CITY OF ALBUQUERQUE

**Re: Santuario De San Martin De Porres Church
Scott McGee's Engineer's Stamp 10-29-14 (M10D002)**

GRADING AND DRAINAGE PLAN

C-101

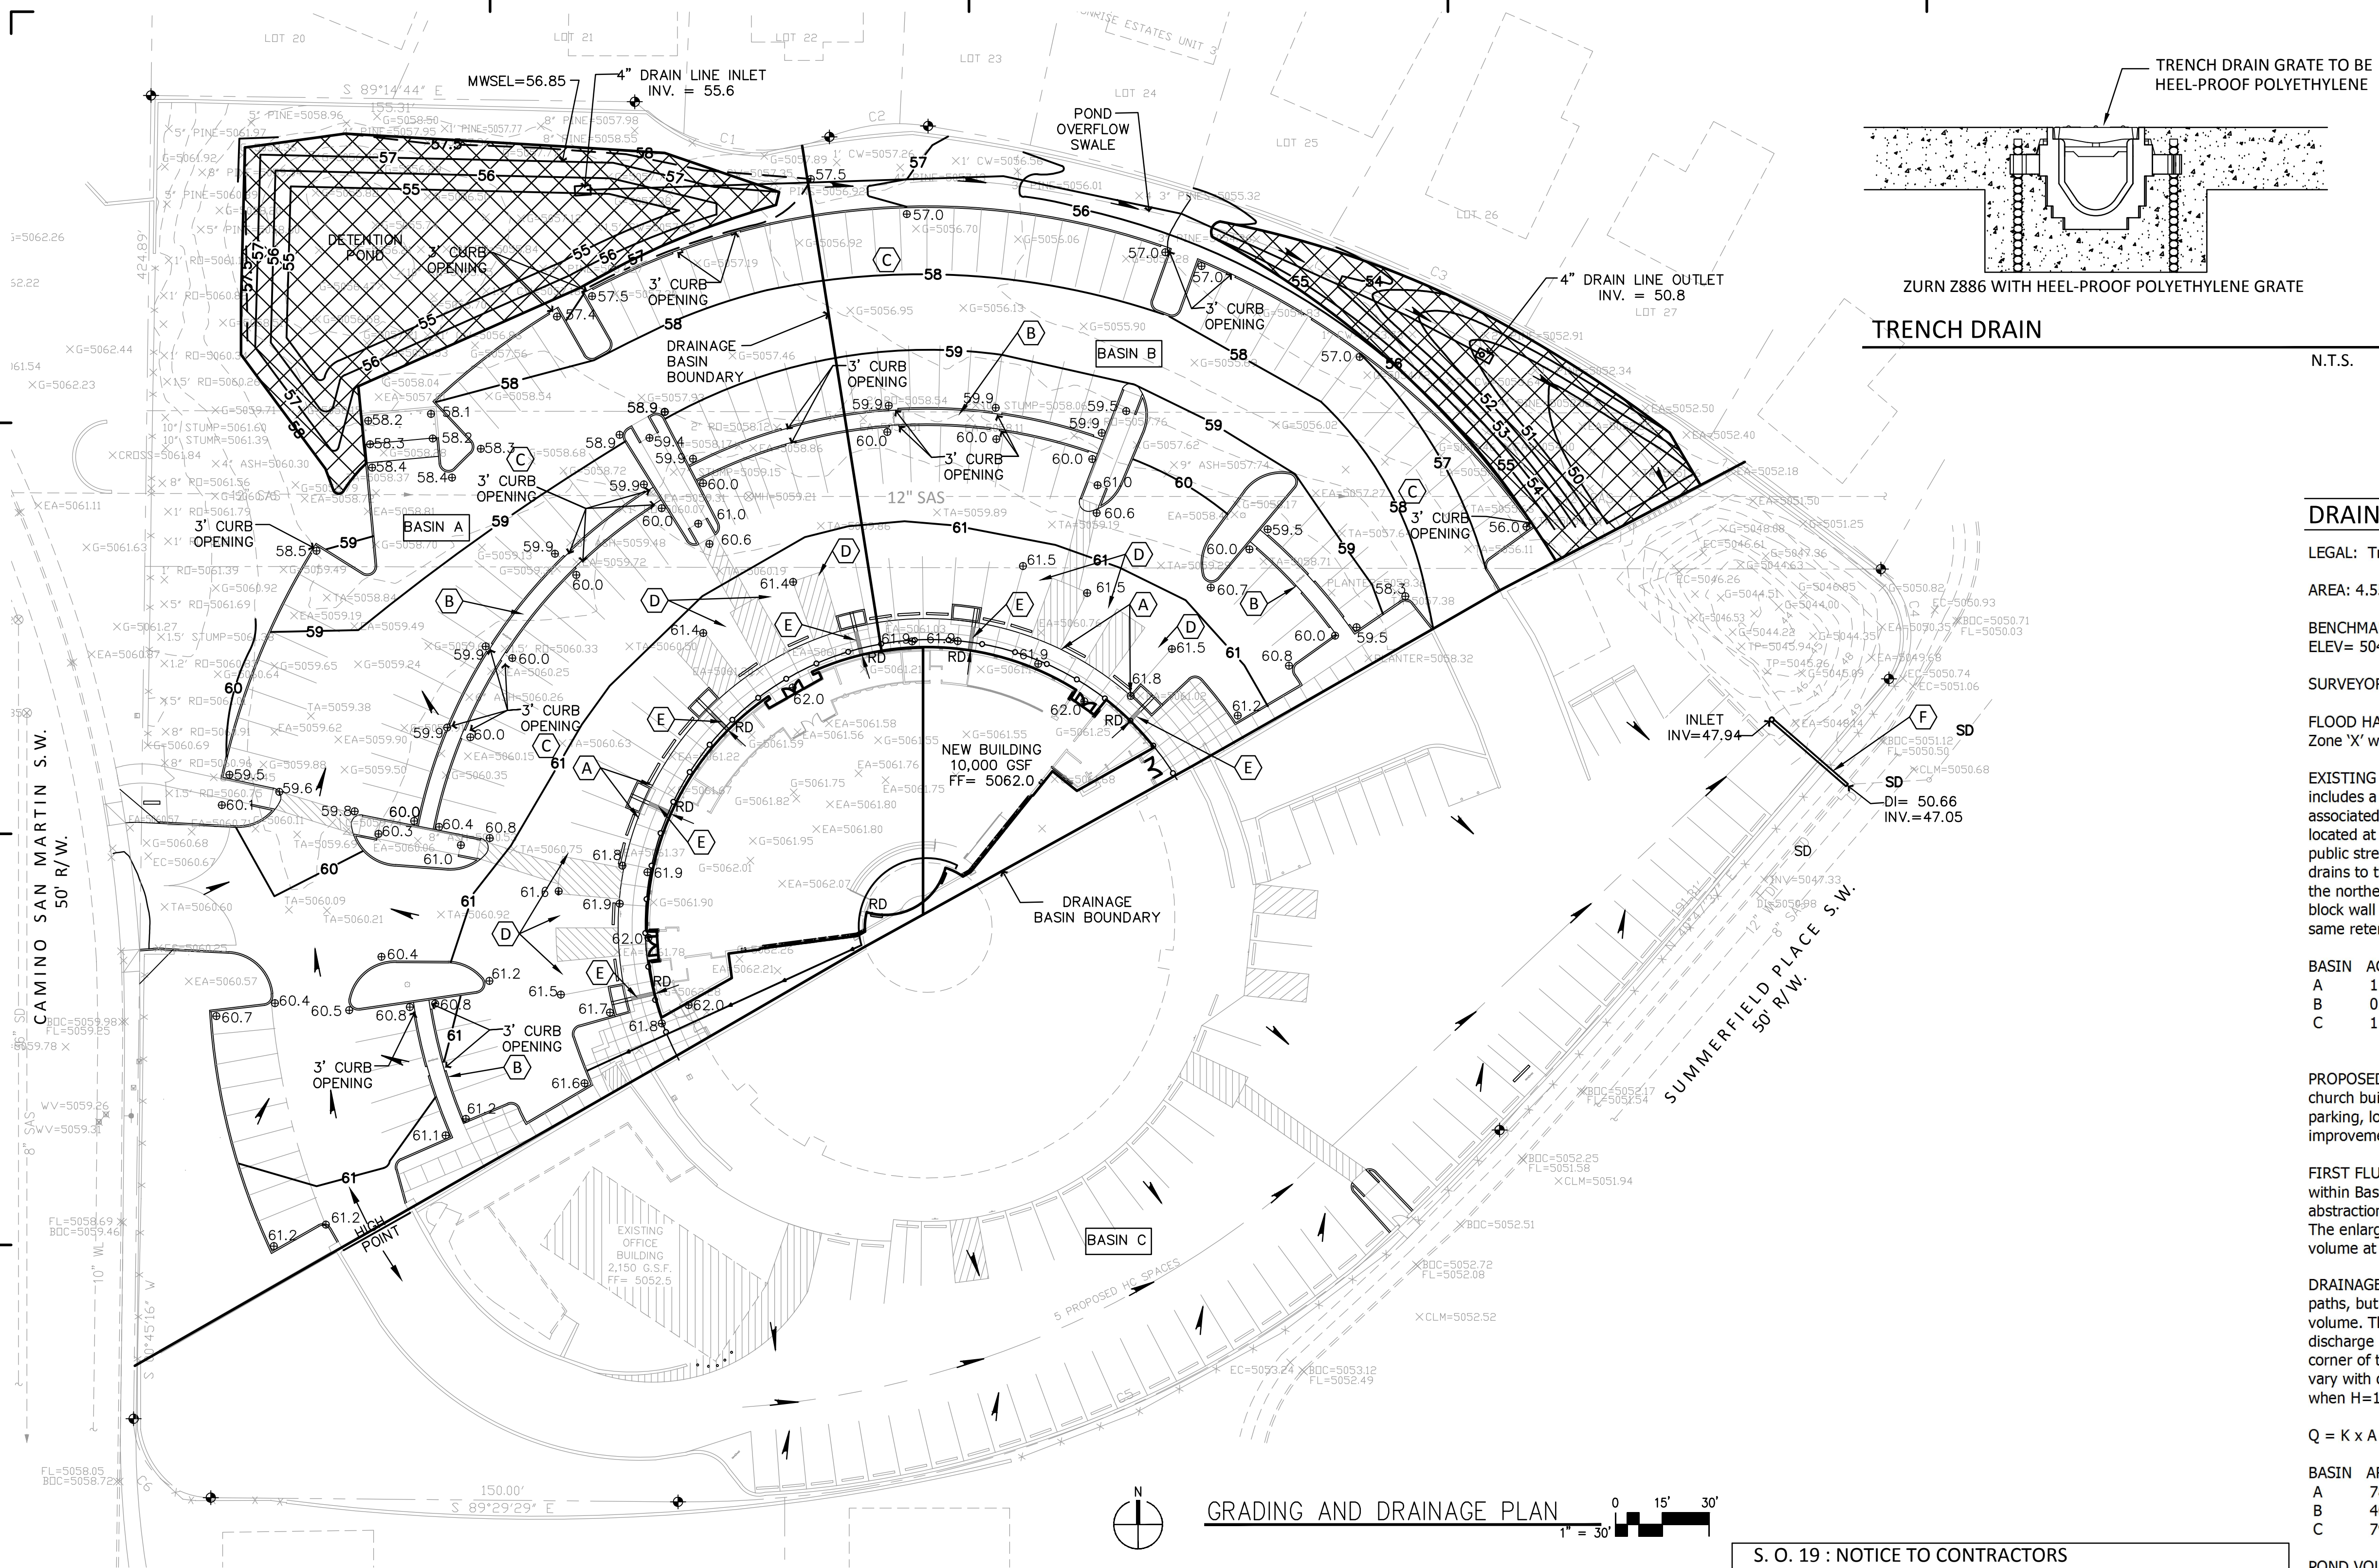
Based upon the information provided in your submittal received October 29, 2014, the above referenced plan is approved for SO-19 and Building Permit. Based on discussions with the Hydrology and you, the discharge will be for a 4 inch outlet instead of 3inch to reduce clogging issues.

A 4" drain line is proposed to discharge storm water to Summerfield Place SW into the back of an existing storm drain inlet. A 4" discharge pipe will be used to control discharge to the allowable 0.1CFS/Acre based on a maximum water depth of 52-48.1= 3.9'

REV 10/29/14: 4" DISCHARGE USED
